Report: Punchlist
Function: Test, Adjust, & Balance
Date: 03/11/2026
Completed By: National TAB

03-09-26 Wawa #8681 Ruckersville, VA

Project: 03-09-26 Wawa #8681 Ruckersville, VA

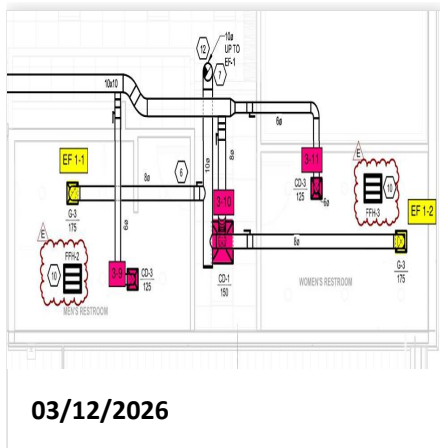
Issue Name : Difficulties Moving Air RTU-3 Supply's
Description : There is difficulty in moving air to the Restroom Area (Women's). Though damper for Women's is wide open, Supply Grille 3-11 is still getting low flow. Main suspect is reduction area from 10" to 6" is inadvertently pushing air to Hallway (3-10) instead, as well as distance from supply drop. RTU-3 is currently balanced out to total airflow.

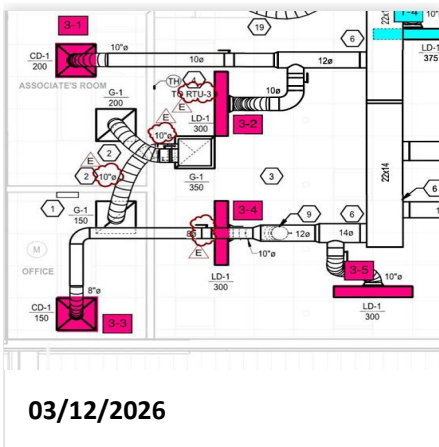
Issue Name : Difficulties Moving Air RTU-3 Supply's Pt. 2
Description : Supply Grille 3-3 currently has airflow above design. Looking above ceiling did not reveal a damper to close 3-3. However, the branch connecting 3-3, 3-4, and 3-5 has a damper controlling the entire branch. RTU-3 is currently balanced out to total flow.

- **03/13/2026 National TAB - John Barresi**
 - Supply Grille 3-3 now has a damper installed.

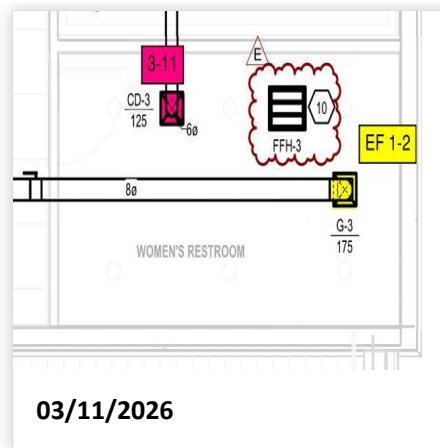
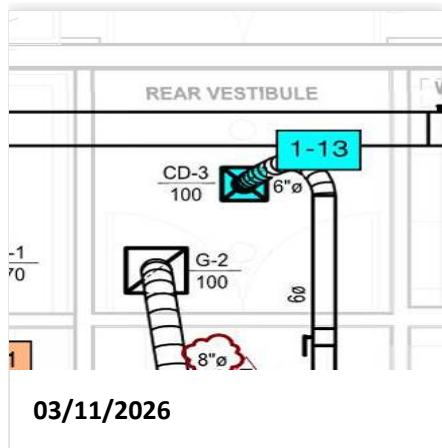
Issue Name : Exhaust Fans Not Running
Description : Both EF-1 and EF-2 are not finished being wired up and are inoperable.
Created By : National TAB **Assigned To :** National TAB - Brianna Biggs
Status : Open
Priority : High **Asset Tag :**
Originated Date : 03/13/2026 - John Barresi - National TAB

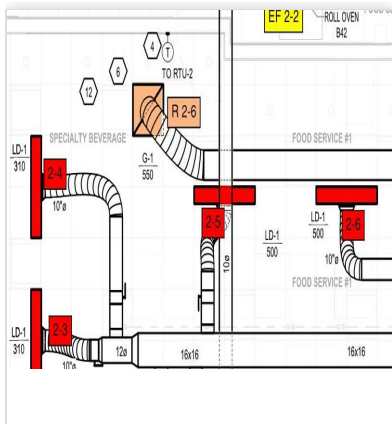
Issue Name : Low CFM Reading Supply Grilles
Description : Supply grilles 1-13 and 3-11 are having difficulty moving air to locations. Dampers for both grilles are confirmed to be full open.
Created By : National TAB **Assigned To :** National TAB - Brianna Biggs
Status : Open
Priority : Medium **Asset Tag :**
Originated Date : 03/11/2026 - John Barresi - National TAB

- **03/12/2026 National TAB - John Barresi**
 - Difficulty moving air to Supply 2-5 as well, dampering down / manipulating surrounding grilles does not push air to 2-5.

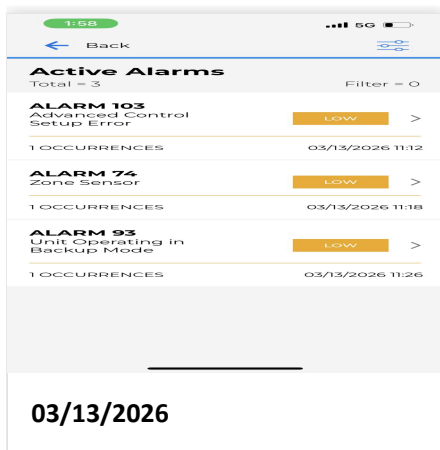
Issue Name : RTU Sensors
Description : Site received bad sensors. Units running as "Stand-Alone" at the moment. Site Super has confirmed this will be rectified 3/12.
Created By : National TAB **Assigned To :** National TAB - Brianna Biggs
Status : Closed
Priority : Medium **Asset Tag :**
Originated Date : 03/11/2026 - John Barresi - National TAB

- **03/13/2026 National TAB - John Barresi**
 - Sensors for units have been installed as of 3/13.

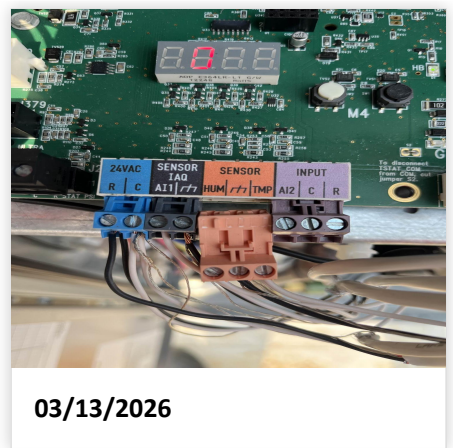
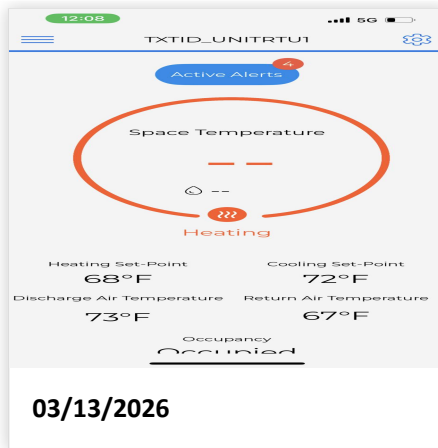
Issue Name : RTU-1 Sensor/Wiring Error
Description : Unit believes that the space is 96F when sensor is connected. Sensor has been unplugged at unit. Unit is currently operating in Return Air Back-Up mode. Sensor faulty/incorrect wiring.
Created By : National TAB **Assigned To :** National TAB - Brianna Biggs
Status : Open
Priority : Medium **Asset Tag :** RTU1
Originated Date : 03/13/2026 - John Barresi - National TAB
